Modification of Consent (Mod 1) State significant development SSD 7628

MOOREBANK PRECINCT EAST STAGE 2 (SSD 7628)

MPE Stage 2 Response to Submissions

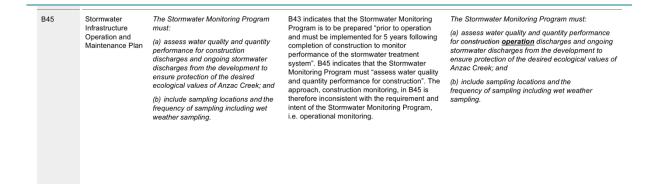
Table 6 included the following proposed modification of CoC B45, presented as an extract of the table below.

The table incorrectly refers to CoC B45. The wording, comment and assumed correct wording of the table refer to CoC B44, as the CoC intended to be modified.

Accordingly, a revised extract of Table 6, updated in accordance with the correct CoC reference and description, is provided below. Proposed additions are shown as **bold underlined** and proposed deletions shown as strikethrough. The content of the proposed modification remains unchanged.
